King Street Pump Station Improvements (Volume I) & ASR Lime System Improvements (Volume II) - RFCSP
Solicitation Number: CO-00670
Job No.: 20-6002 and 22-8603

ADDENDUM 2
October 12, 2023

1 WELL NO. 6
SCALE: 3/8" = 1'-0"

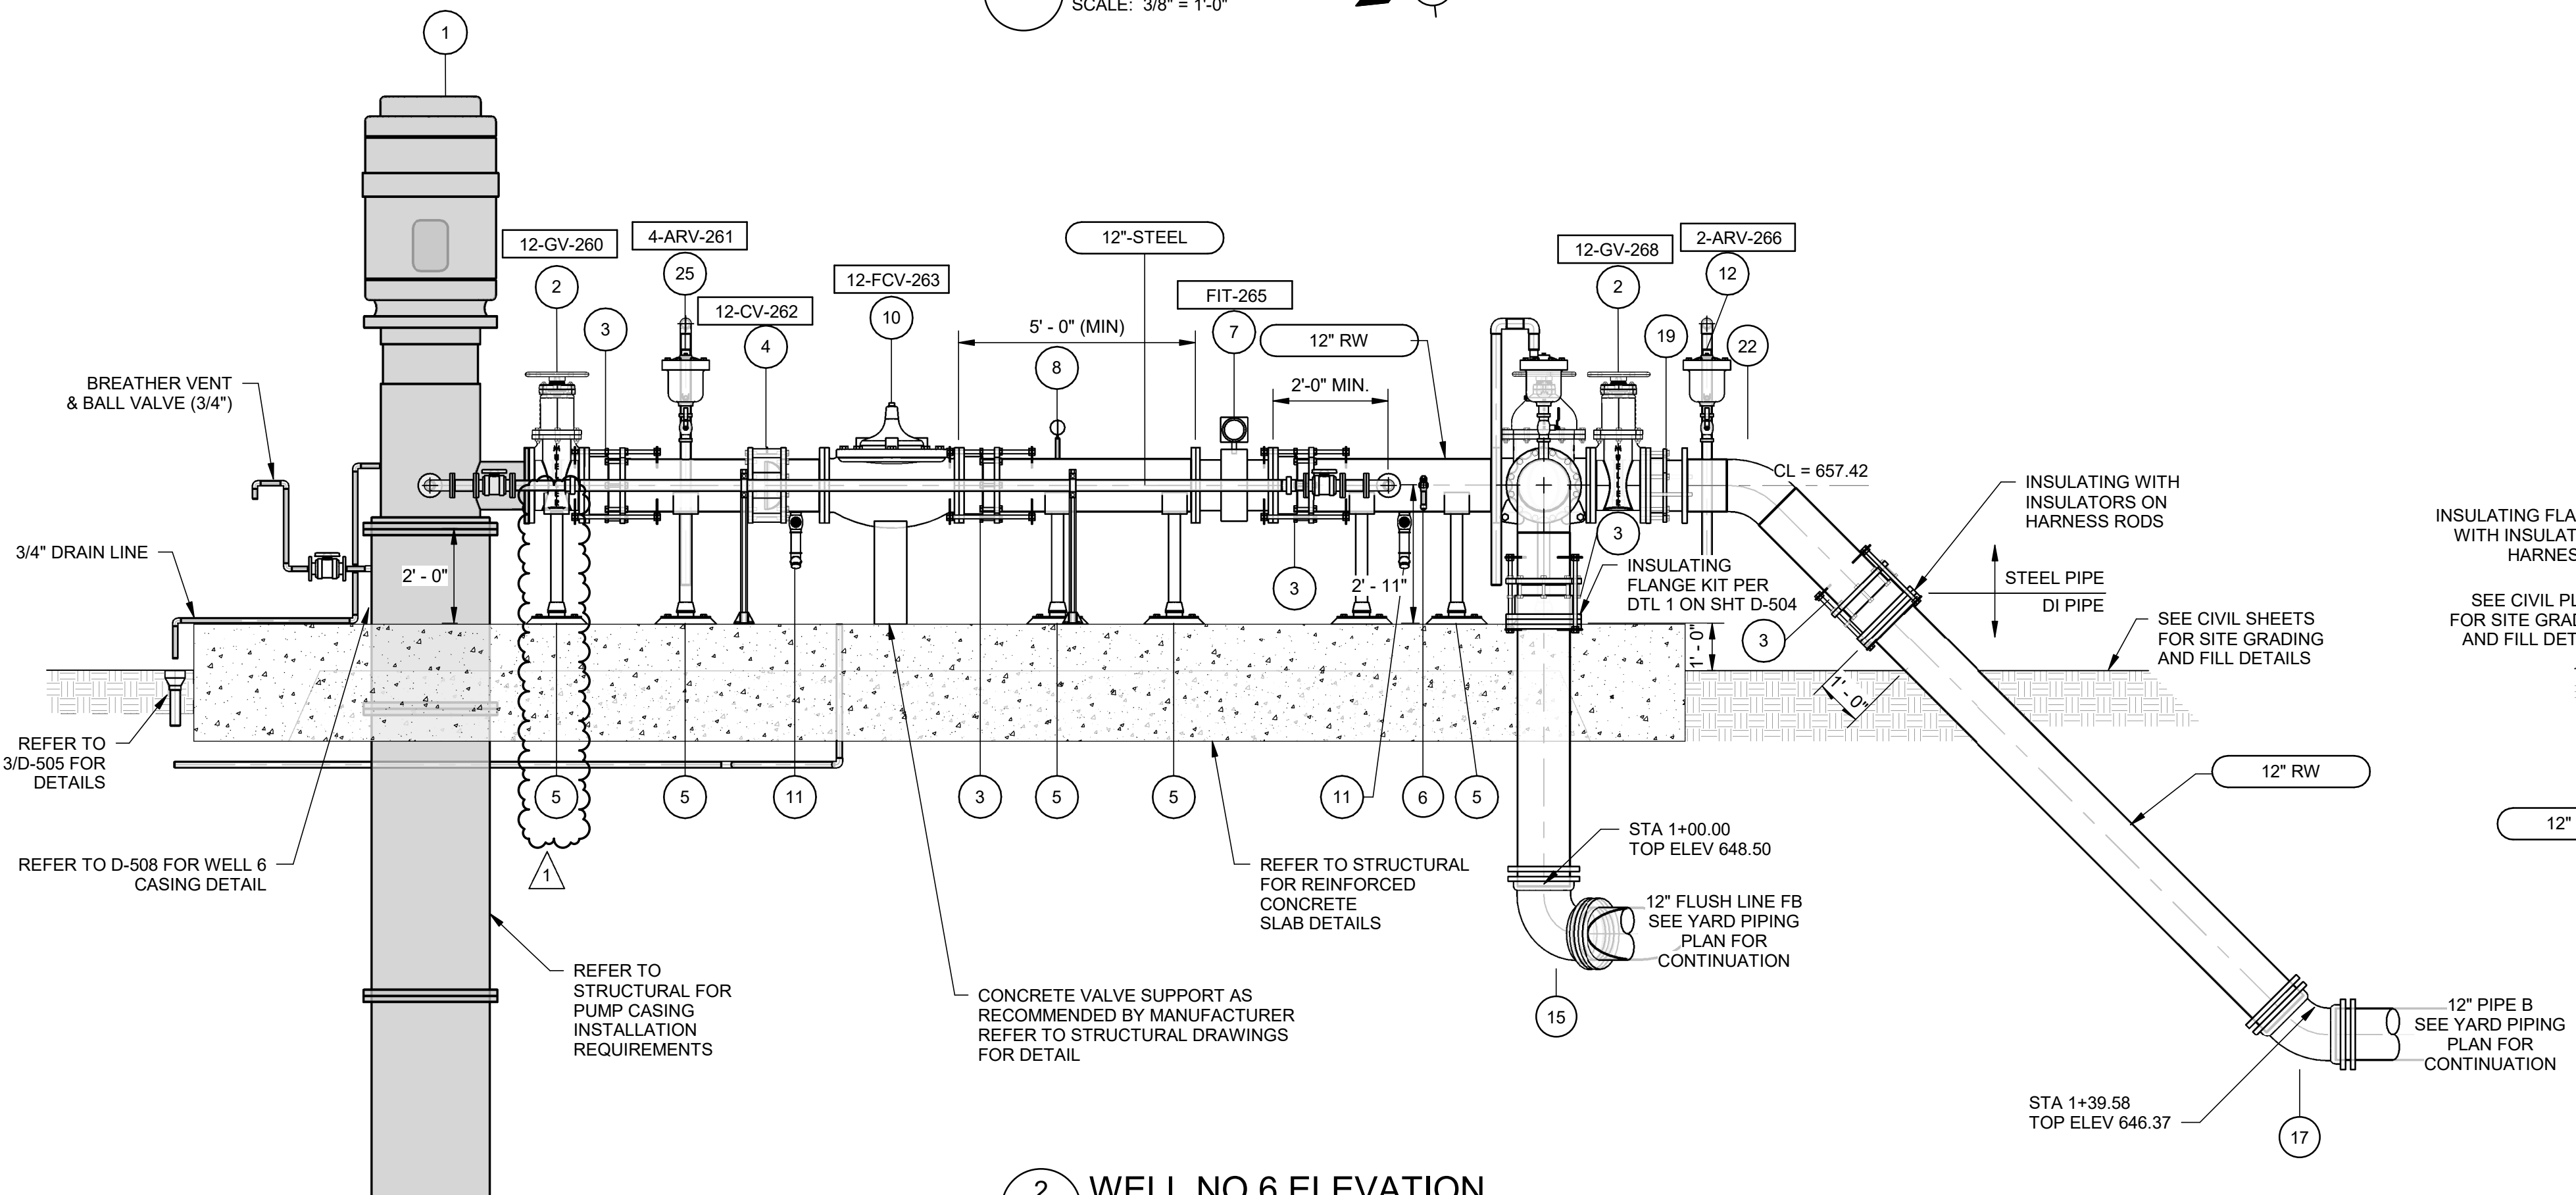
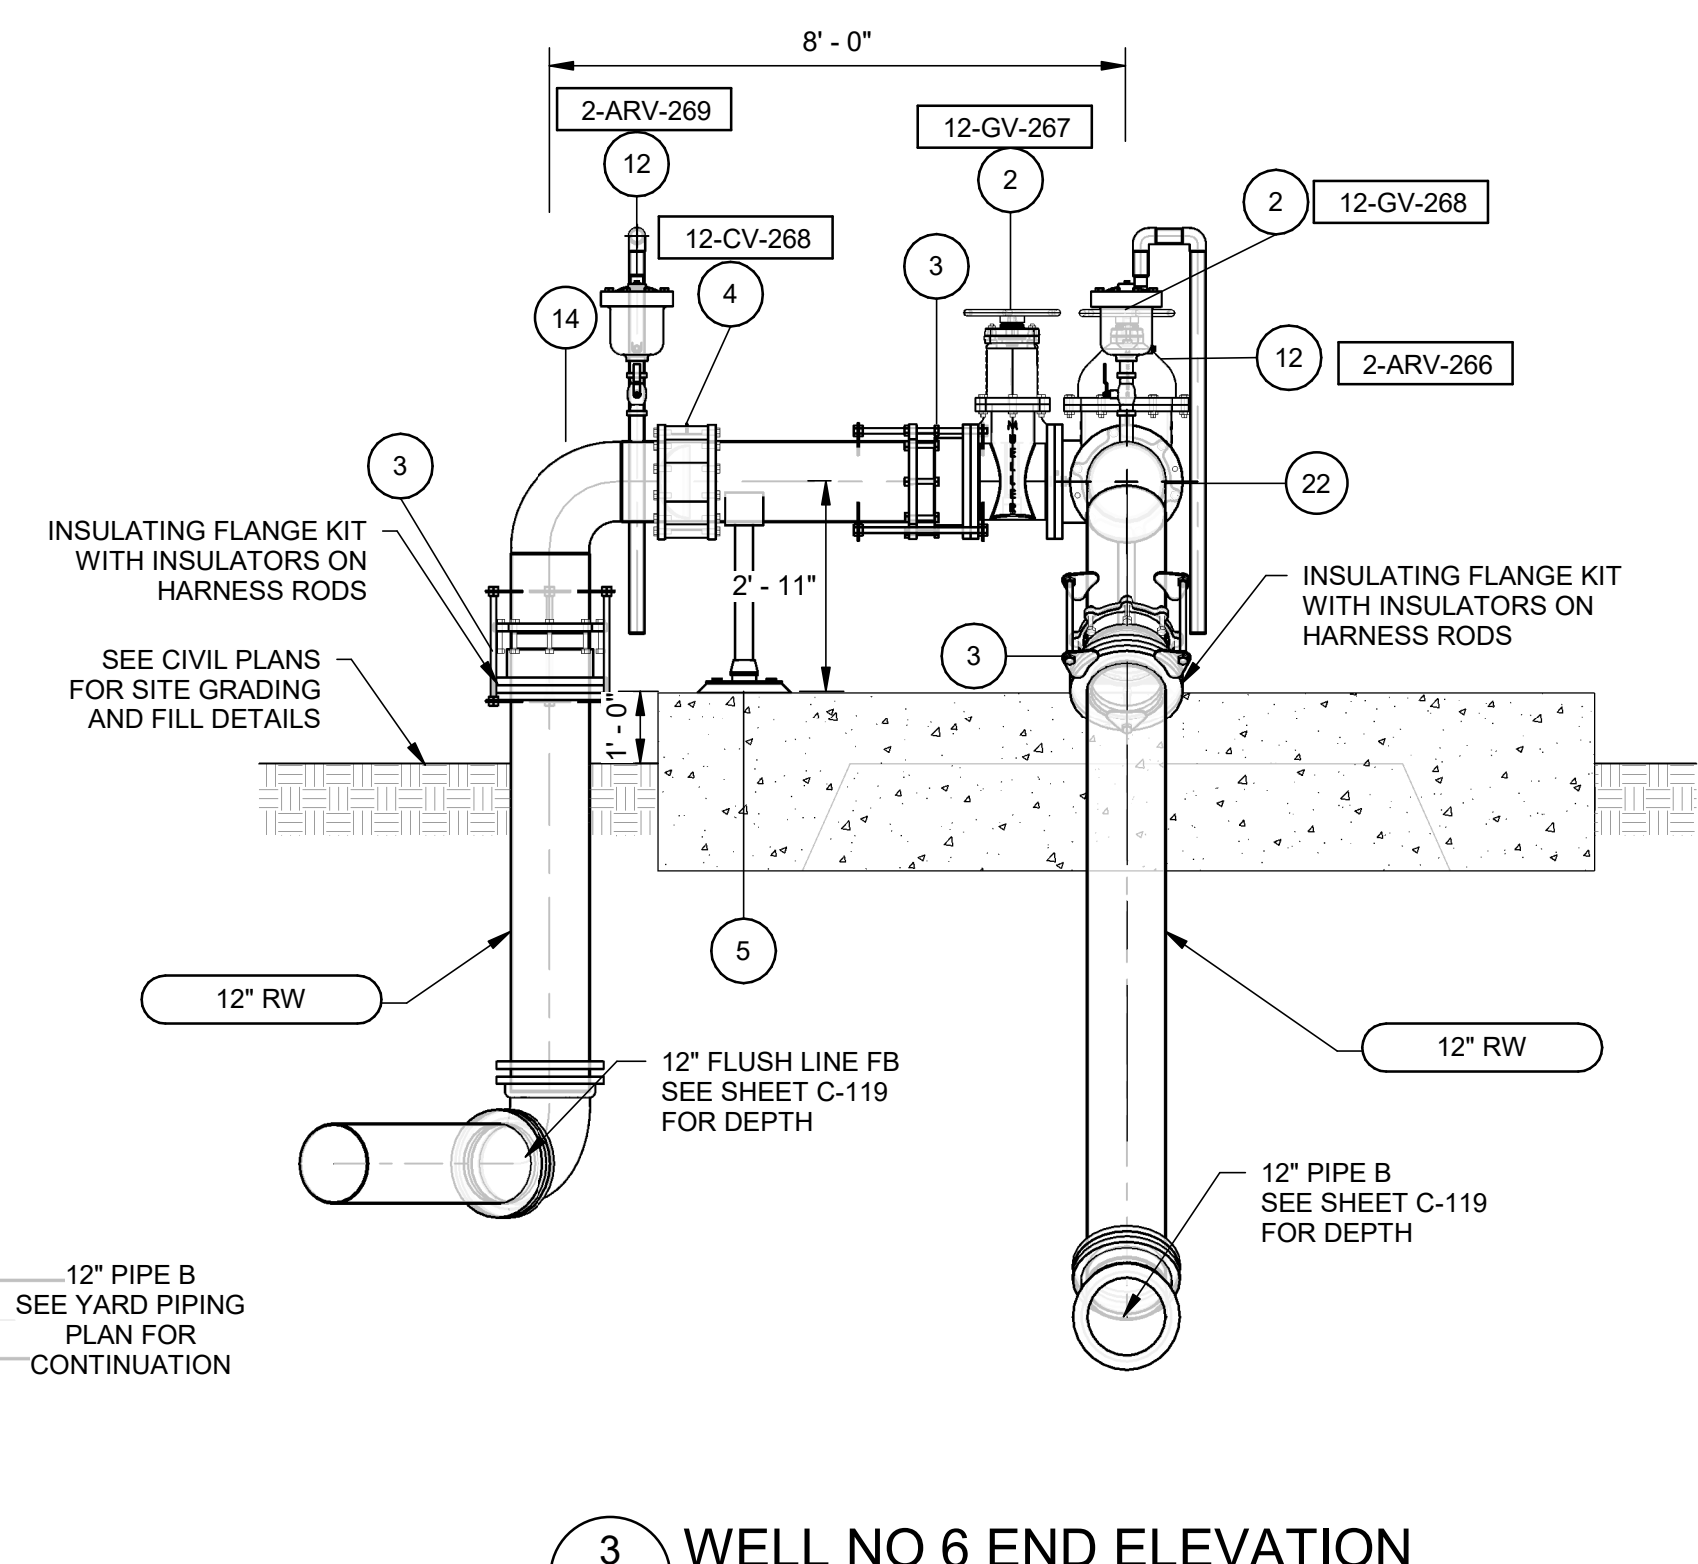
- 49. Question: Contract Drawings, Sheet D-203/204, add permanent pipe support under 12" gate valve that completely supports weight. Pump discharge should not be anchor point for any of discharge piping.**

Response: Refer to "Changes to the Plans" section item No. 3, item No. 4, item No. 5, and item No. 6 in this addendum. Pipe support added to drawings.
- 50. Question: Contract Drawings, Sheet D-203/204, add housekeeping pad/foundation around well casing pipe extended above finish floor. Surface plate assembly will be welded to well casing after installation/leveling. Grout to be poured up to bottom surface of top plate of the surface plate assembly.**
